ADDENDUM

ADDENDUM NO.: **01**

PROJECT NAME: **Lake View High School Renovation Project**

DATE OF ISSUE: **April 19, 2017**

M1.2

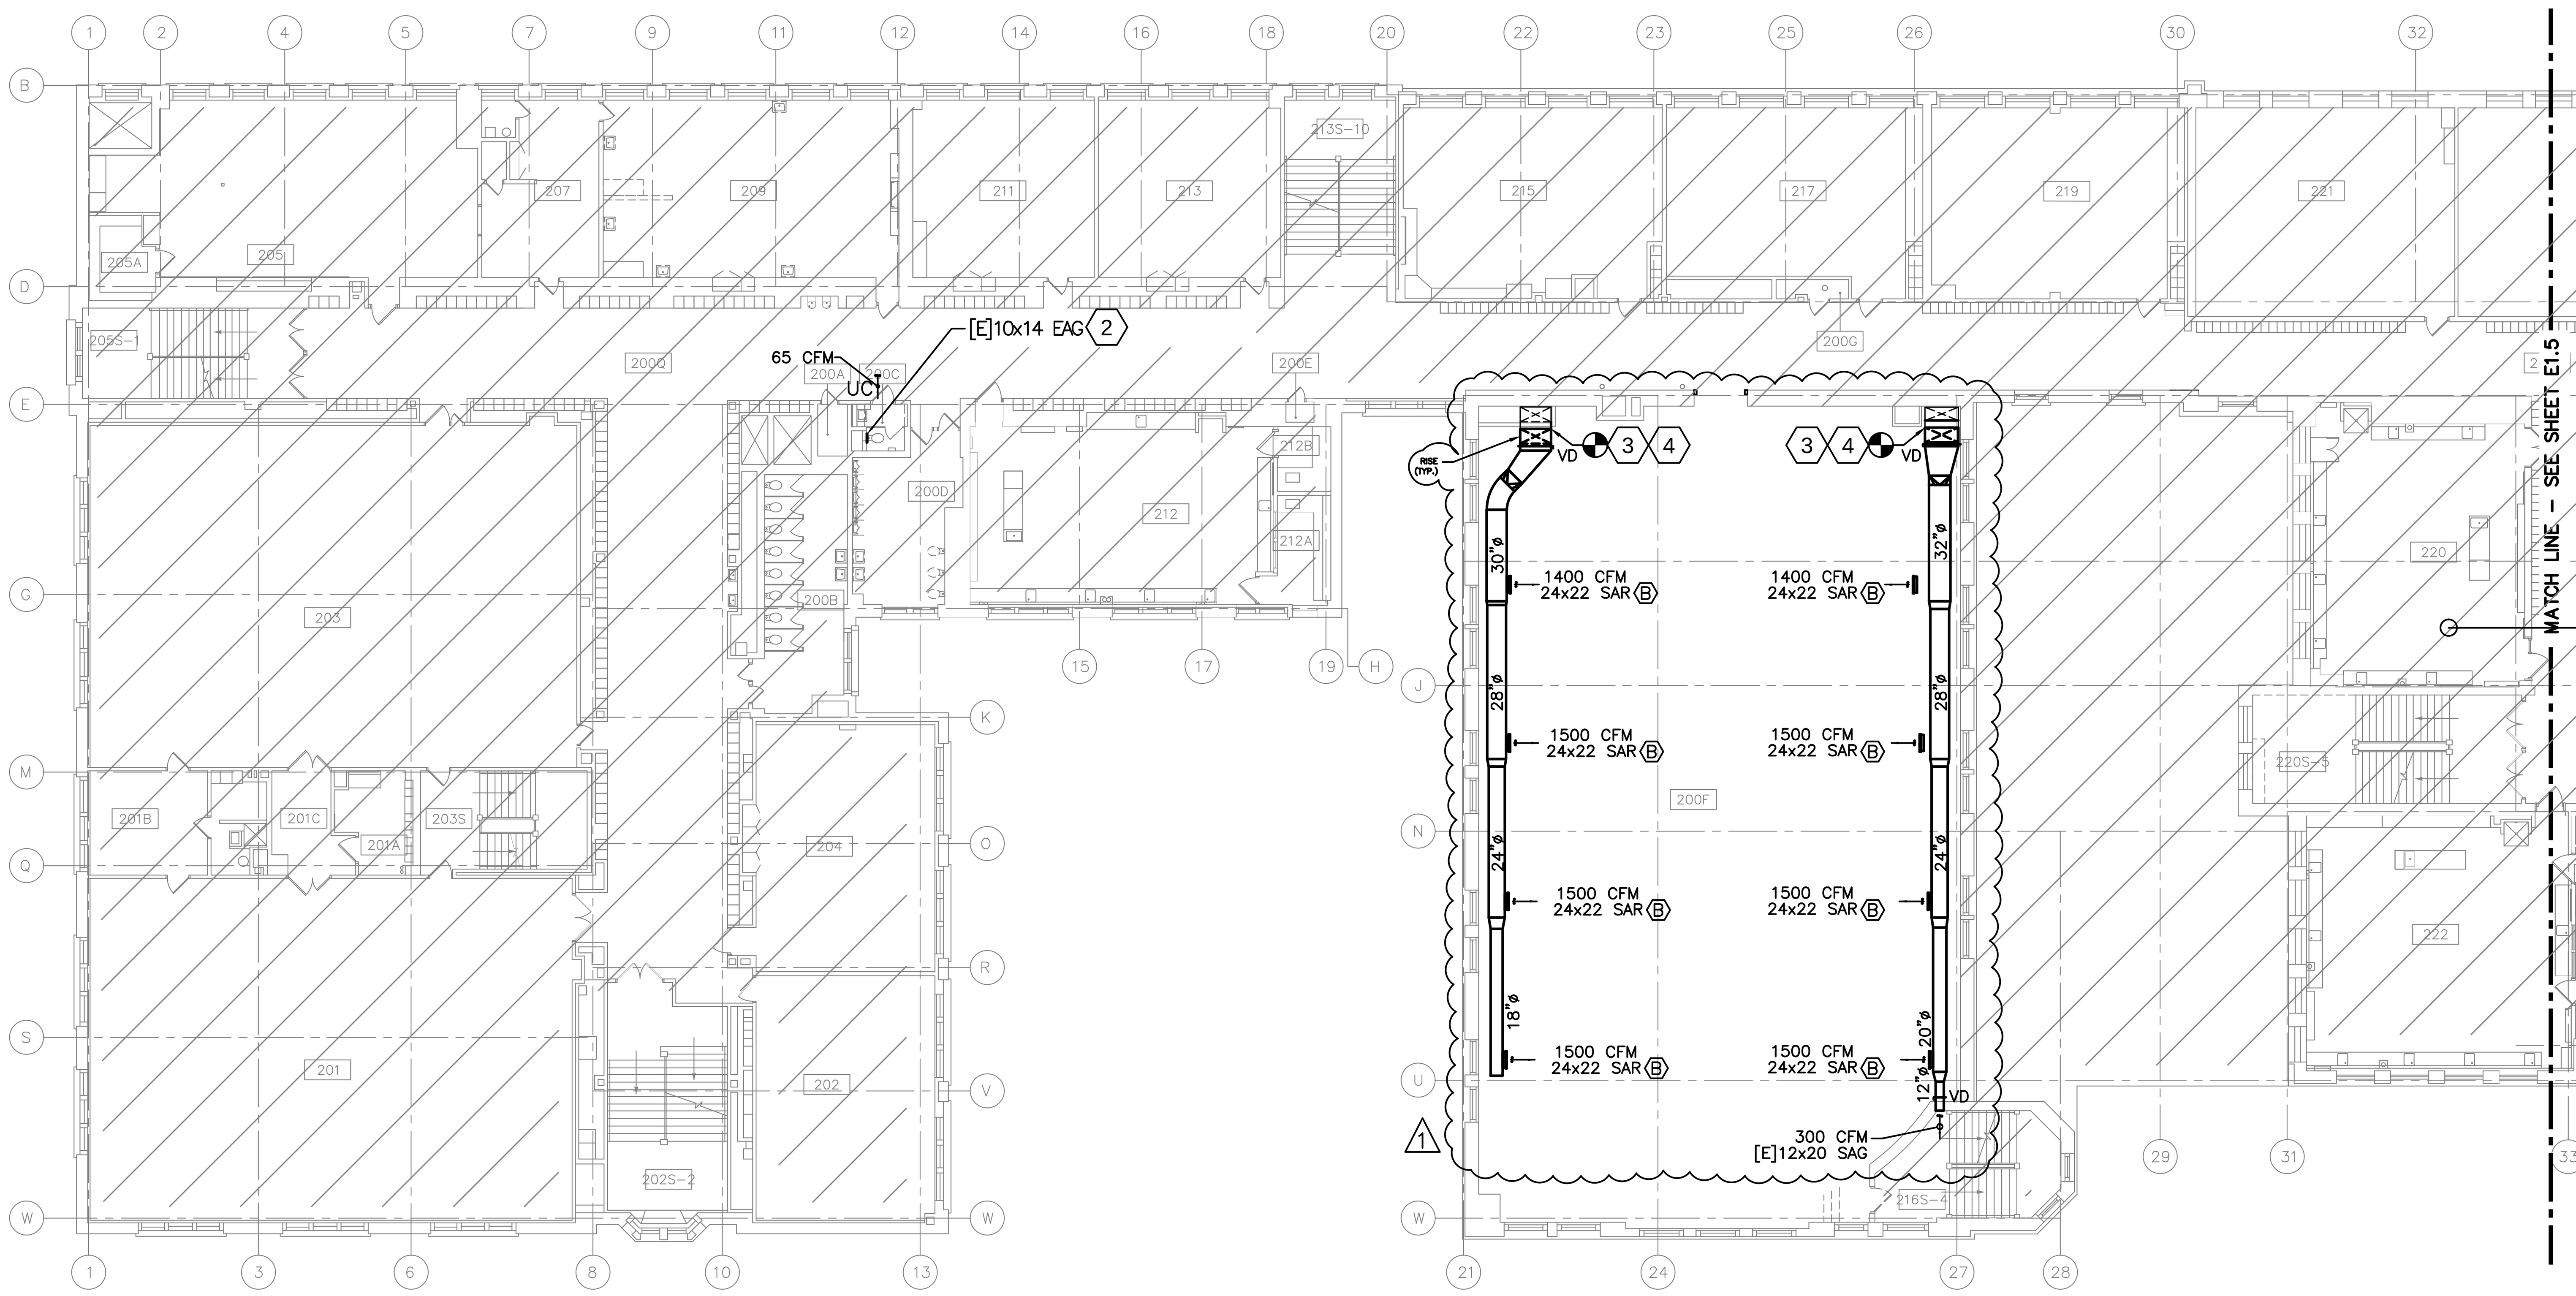
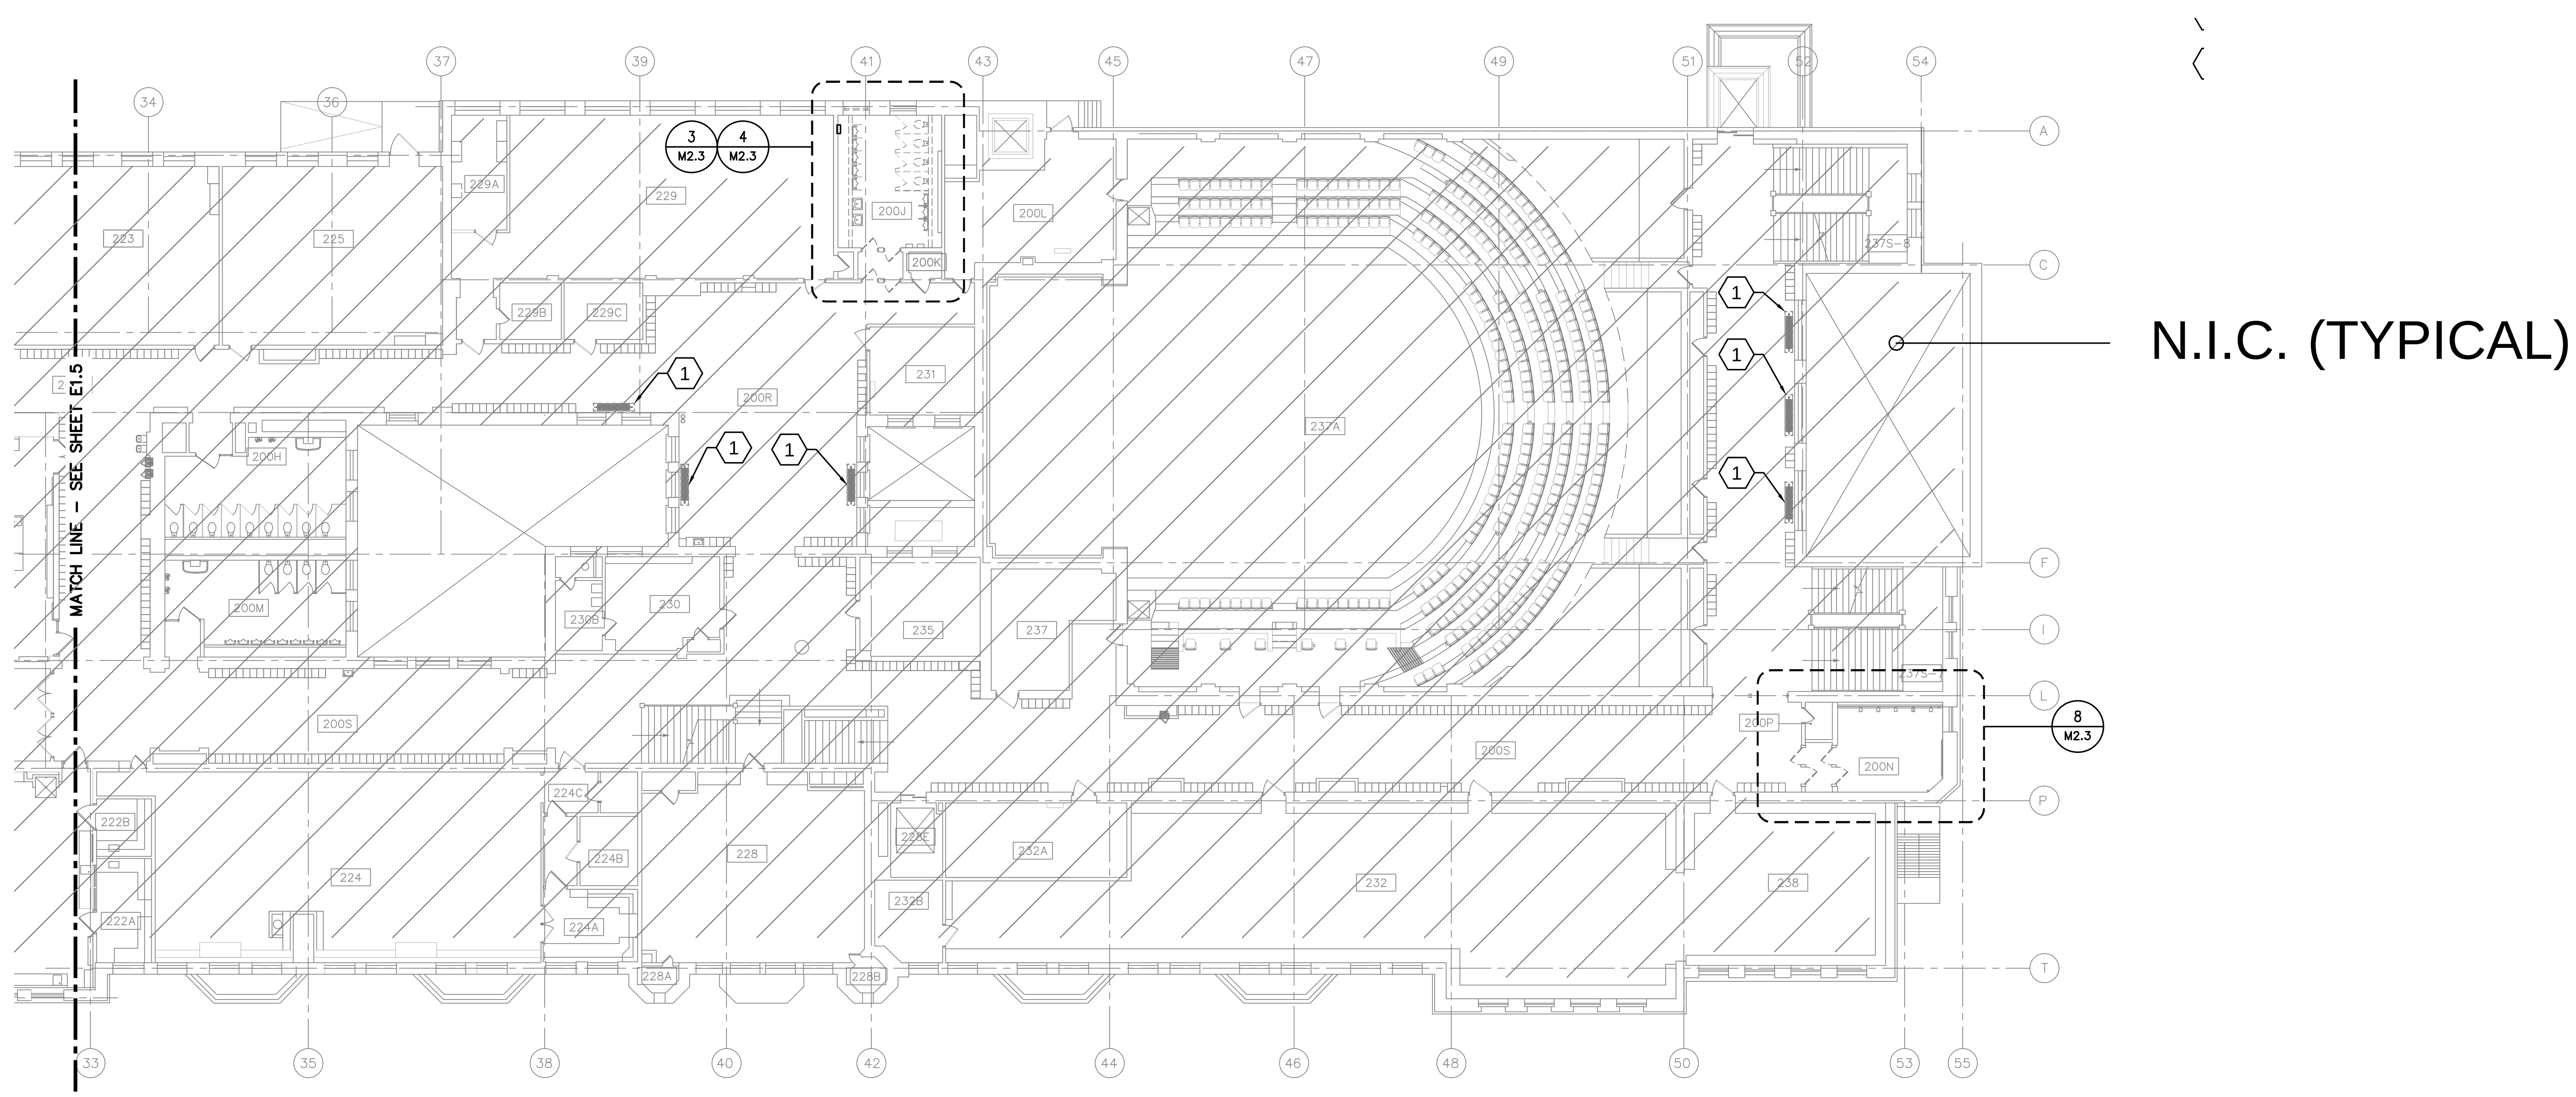
m. **REVISED** Drawing No. M1.0, BASEMENT MECHANICAL REFERENCE PLAN: Changed duct run to Rooms 030A & 030B.
n. **REVISED** Drawing No. M1.2, SECOND FLOOR MECHANICAL REFERENCE PLAN: Changed ductwork in Room 200F from rectangular to round.

7 ROOM 100E – MECHANICAL PLAN
1/8"=1'-0"

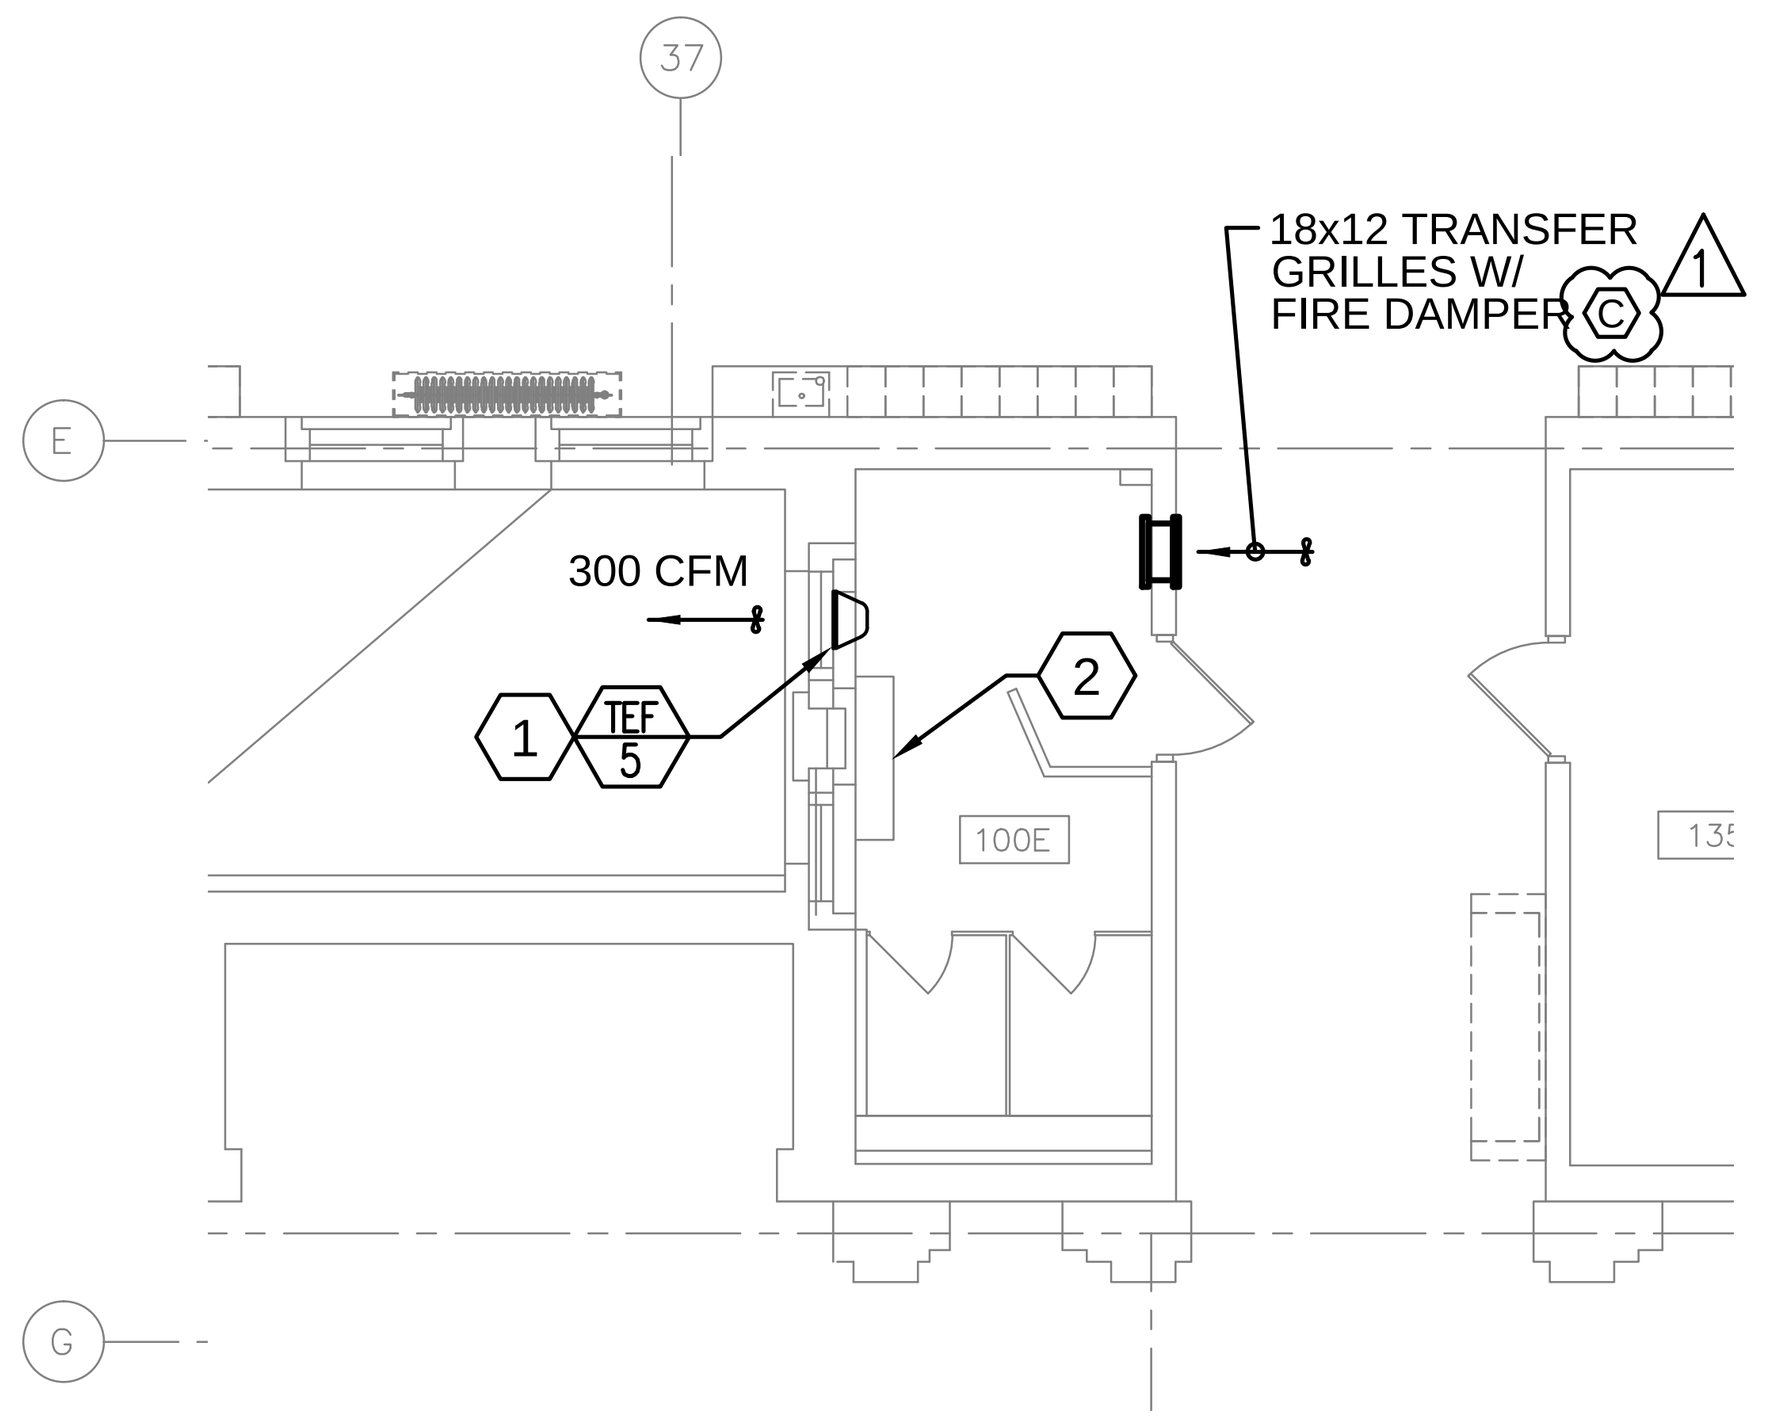
s. **REVISED** Drawing No. M2.2, BASEMENT ENLARGED MECHANICAL PLANS: Changes in Notes 2, 7, & 8.
t. **REVISED** Drawing No. M2.3, ENLARGED MECHANICAL PLANS: Added removal of existing fan in Room 100I and added grille type in Room 100E.
